August 26, 2009
NRC3-09-0020

Subject: Detroit Edison Company Submittal of Final Safety Analysis Report (FSAR) and
Emergency Plan Changes Associated with Revised Fermi 3 Site Plan

Summary of Fermi 3 FSAR Changes & Fermi 3 FSAR Markup

Fermi 3 Emergency Plan Changes

Figure 2.4-211 Fermi 3 Site Plan

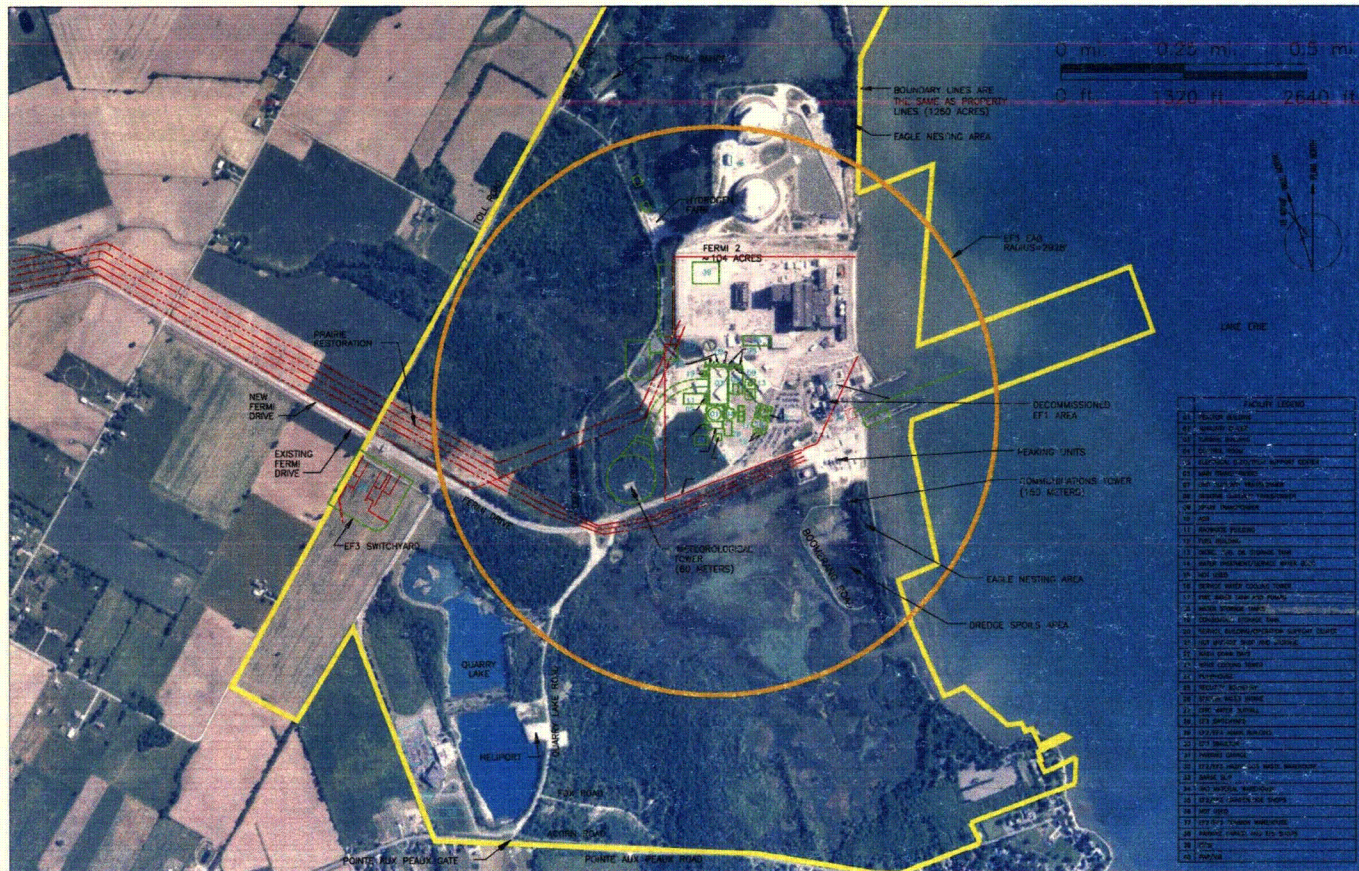
2.4	Hydrology	<p>Section 2.4.2, including Tables 2.4-213 and 2.4-214 are updated to reflect the changes to areas of the sections of the Fermi 3 grade elevation made due to moving the Service Water/Water Treatment (SW/WT) Building.</p> <p>Figure 2.4-211 is revised to reflect new site layout.</p> <p>Figures 2.4-215 and 2.4-217 are revised to</p>

Figure 2.4-215 Final Grade Drainage Areas

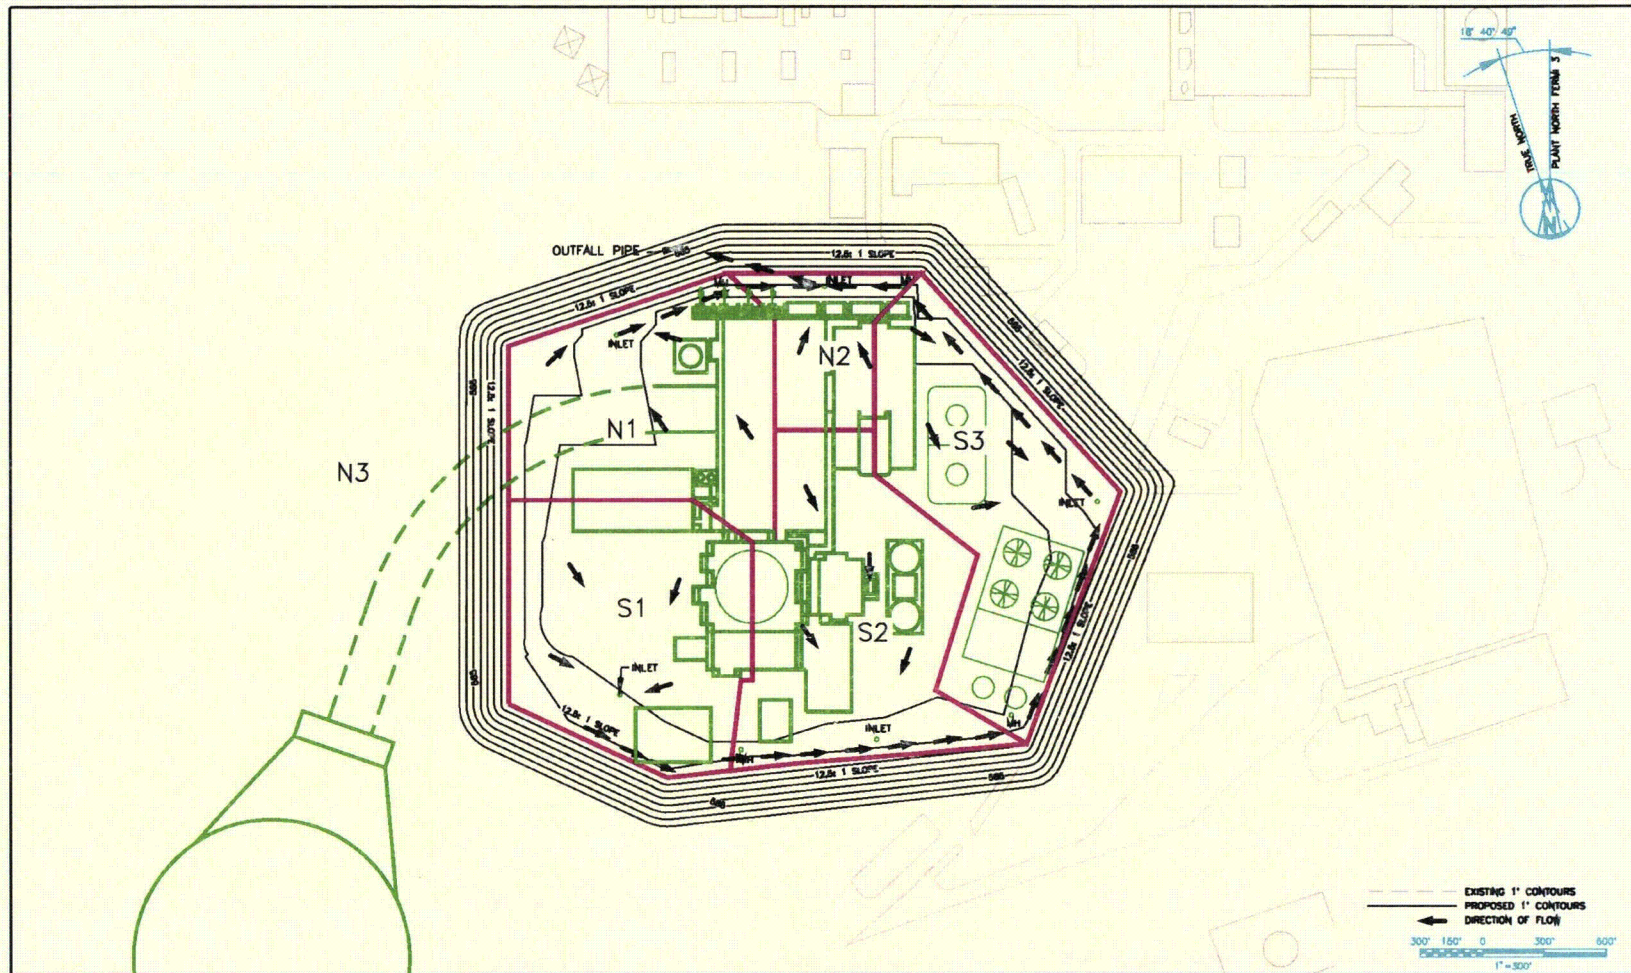
FSAR Chapter	Sections Impacted	Topics	Comments
			reflect location change for SW/WT Building. Figure 2.4-218 is revised to reflect the new location for the CIRC System NDCT.

Figure 2.5.1-235 Site Exploration Plan

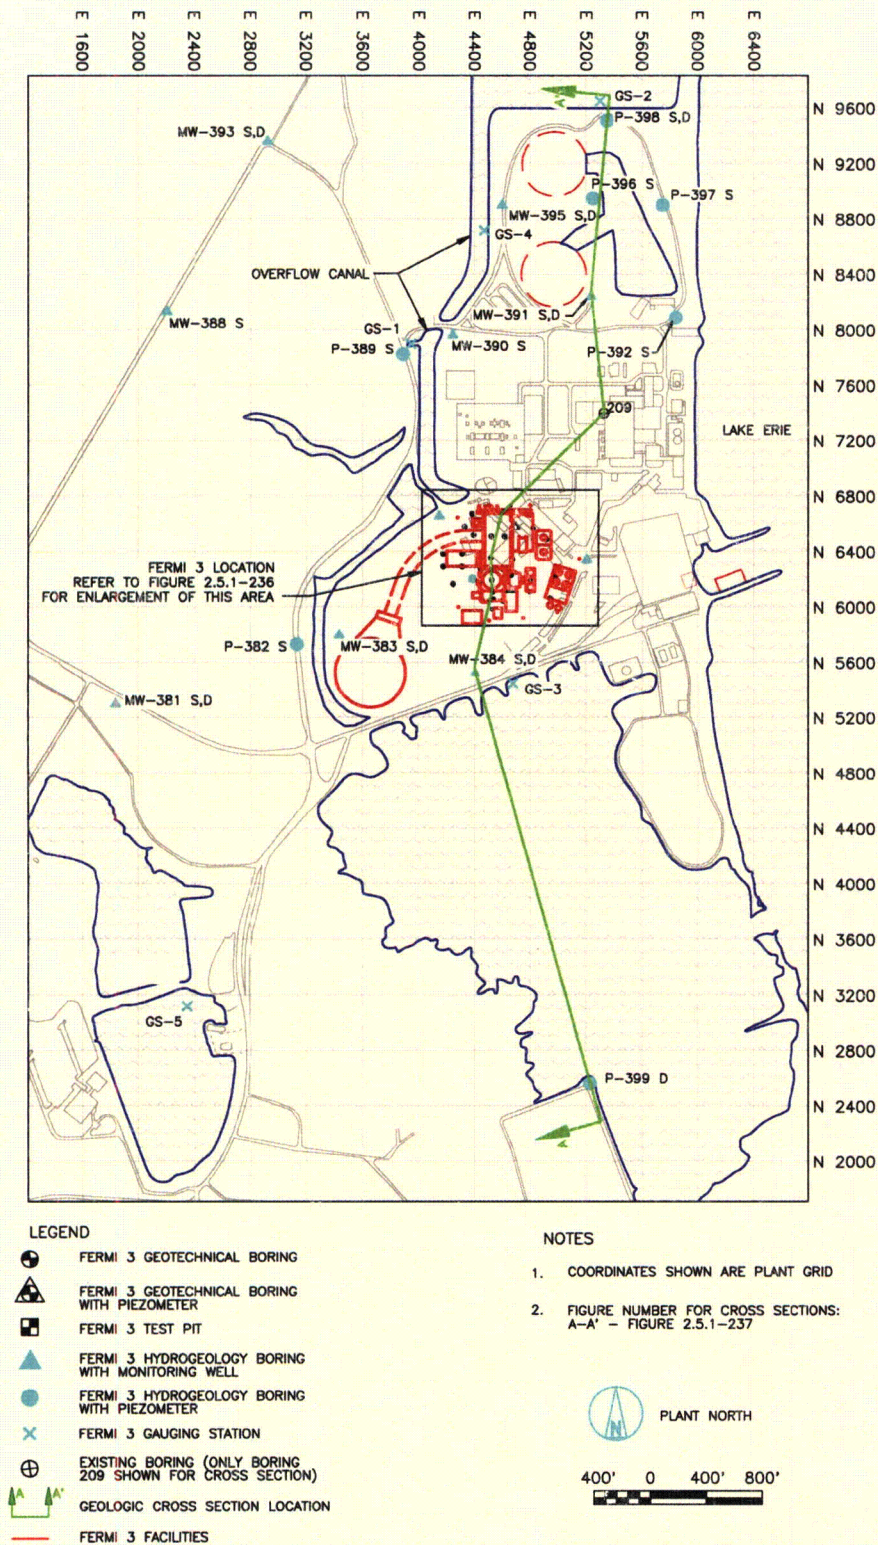
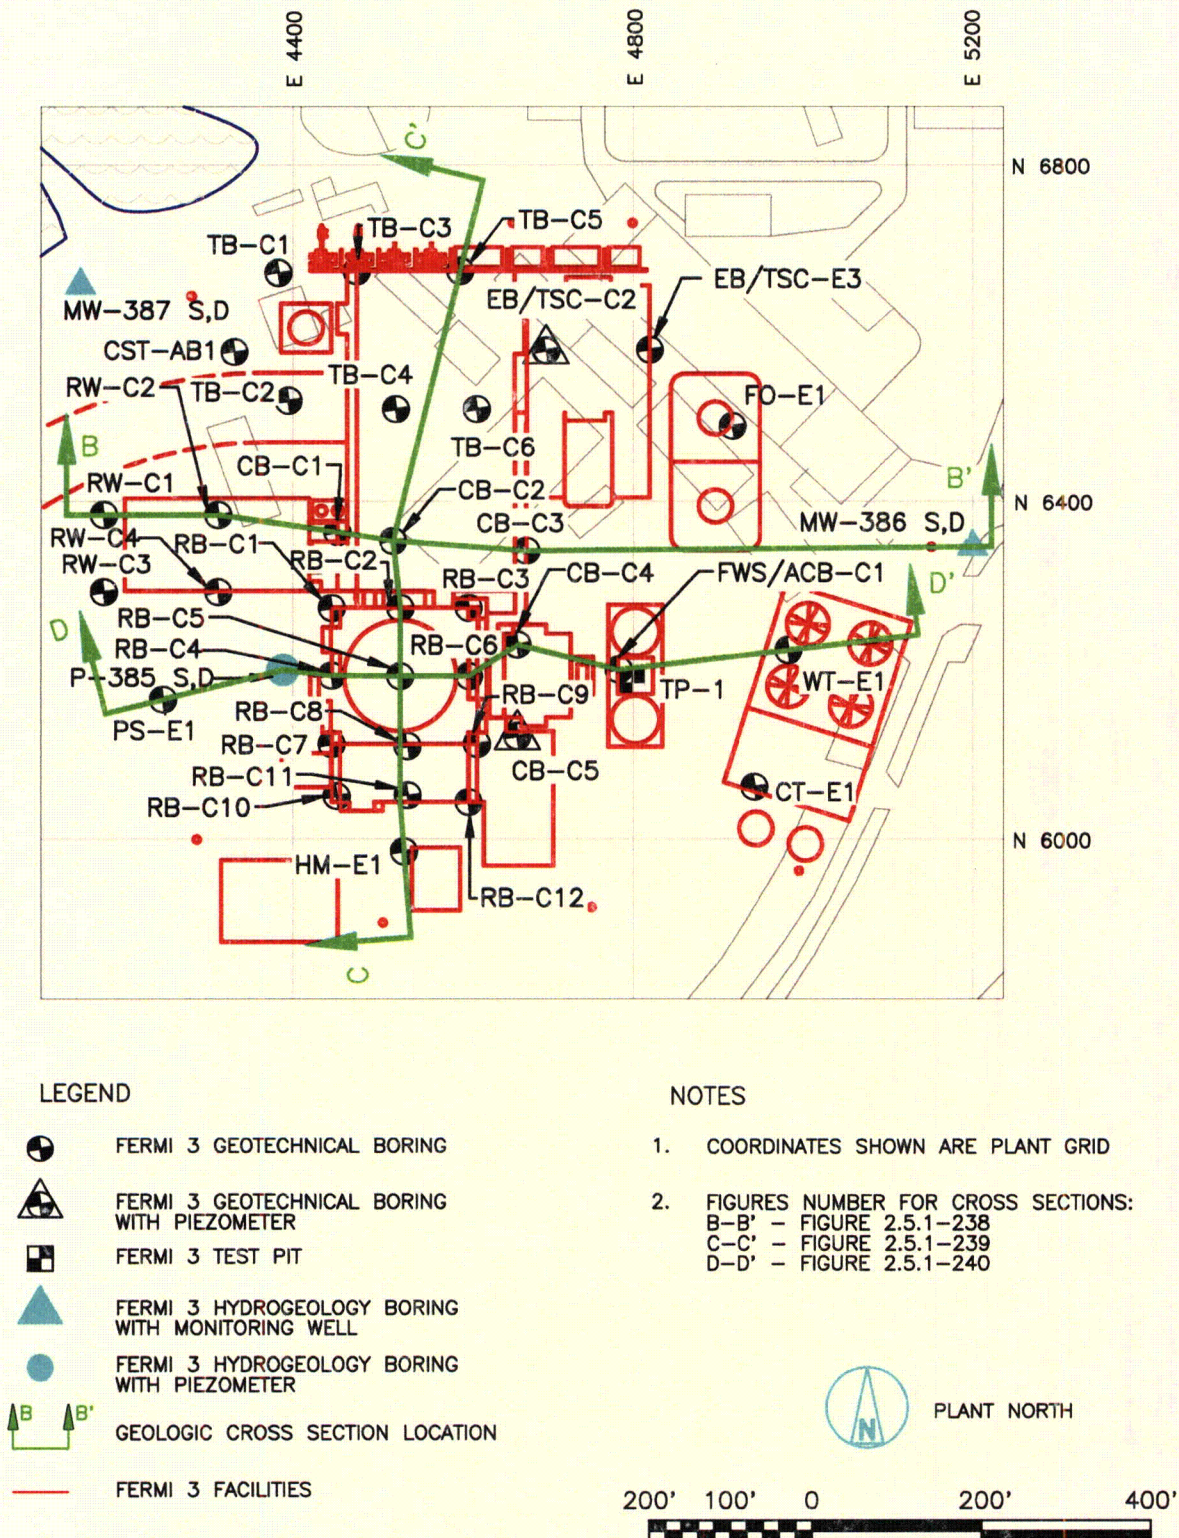
2.5	Geotechnical	Figures 2.5.1-235 and 2.5.1-236 are revised to reflect the new locations of the CIRC System NDCT and SW/WT Building.
3	No Impact		
4	No Impact		
5	No Impact		
6	No Impact		
7	No Impact		
8	Section 8.2	Offsite Power Systems	Sections 8.1 and 8.2 are revised to reflect the new location for the Fermi 3 switchyard. Figure 8.2-201 is revised to reflect the new one-line diagram for the Fermi 3 switchyard. Figure 8.2-202 is deleted as the location of the Fermi 3 switchyard. The Fermi 3 switchyard is adequately depicted on the revised Figure 2.1-204 and the description of the pathway for the transmission lines from the Fermi 3 switchyard is adequately described in Section 8.2.
9	Appendix 9A	Fire Hazards Analysis	Figure 9A.2-33R revised to reflect location change for SW/WT Building.

Figure 8.2-201 345 kV Switchyard Single-Line Diagram

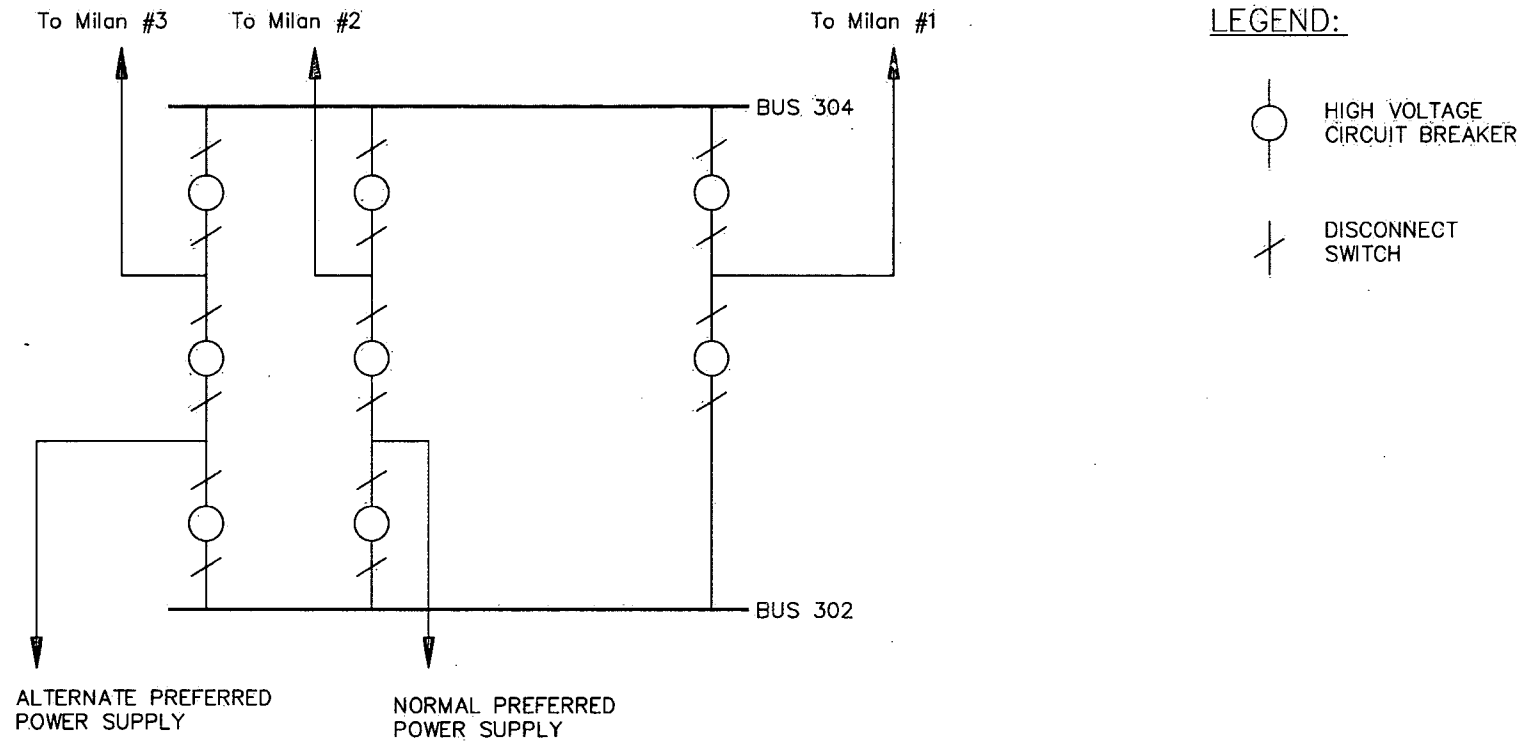
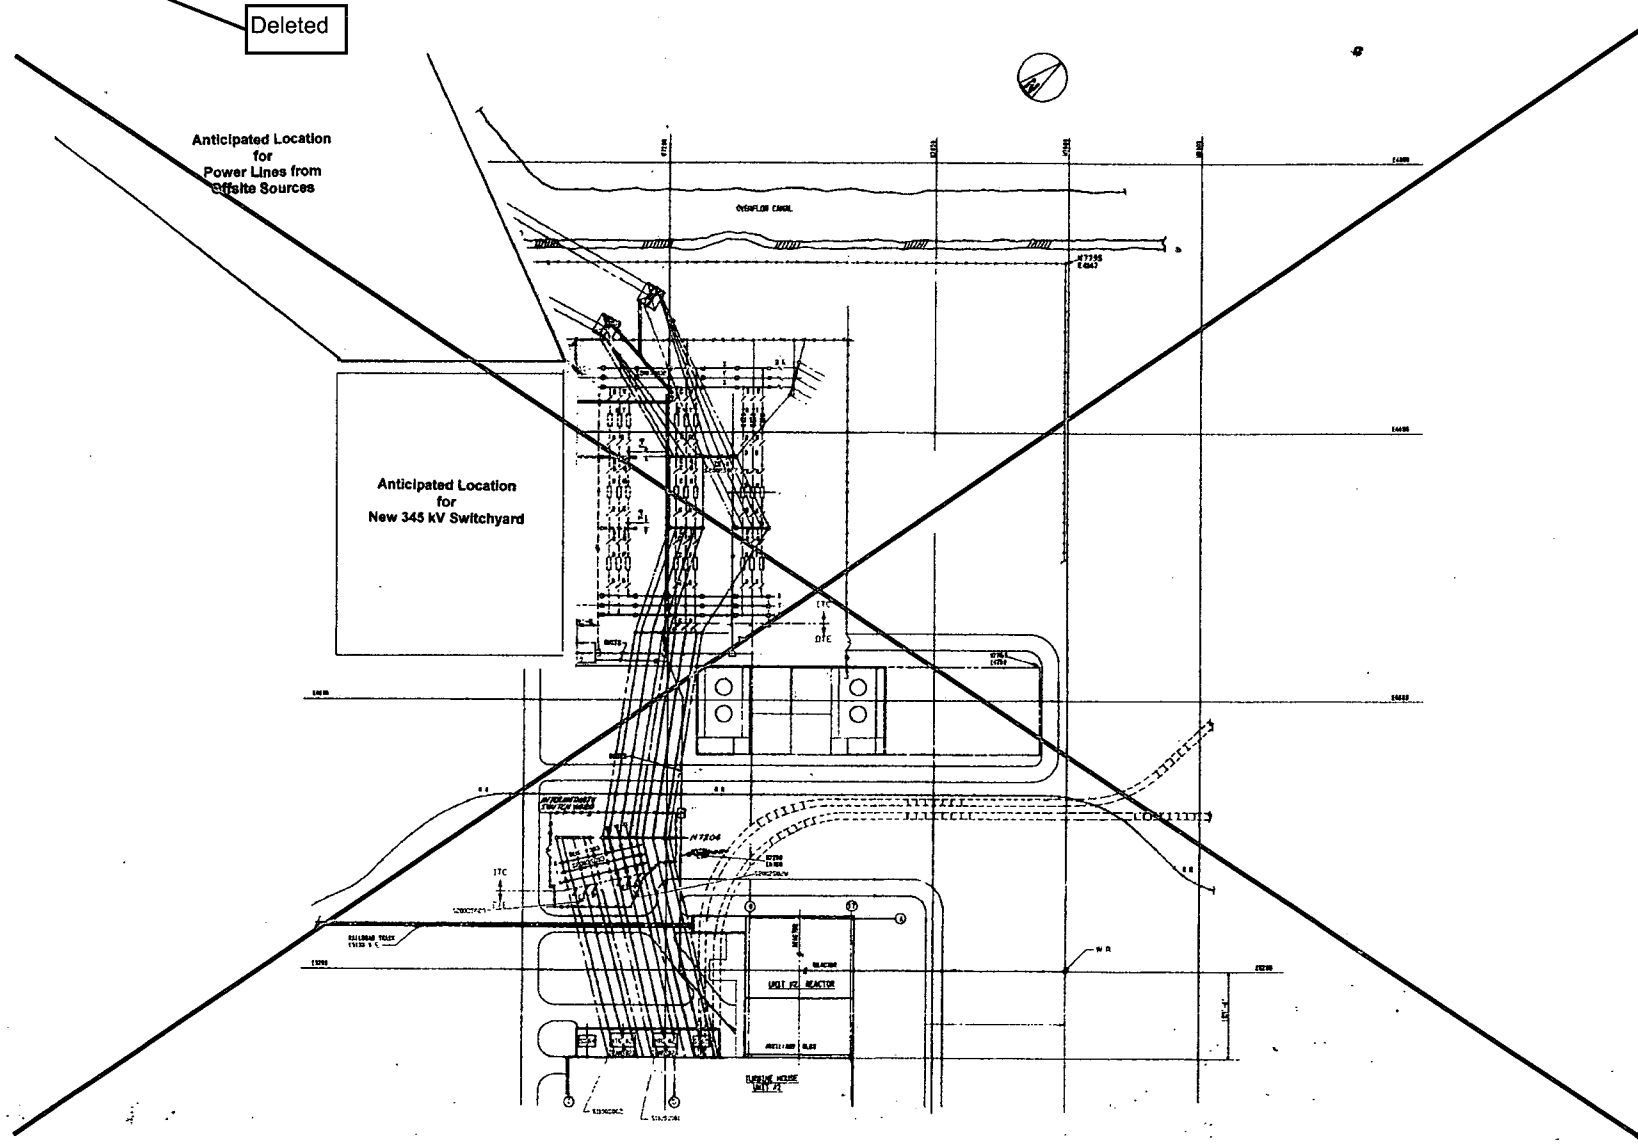
The anticipated physical location and electrical interconnection of the 345 kV switchyard for Fermi 3 is shown on ~~Figure 8.2-201 and Figure 8.2-202.~~

Figure 2.1-204 and
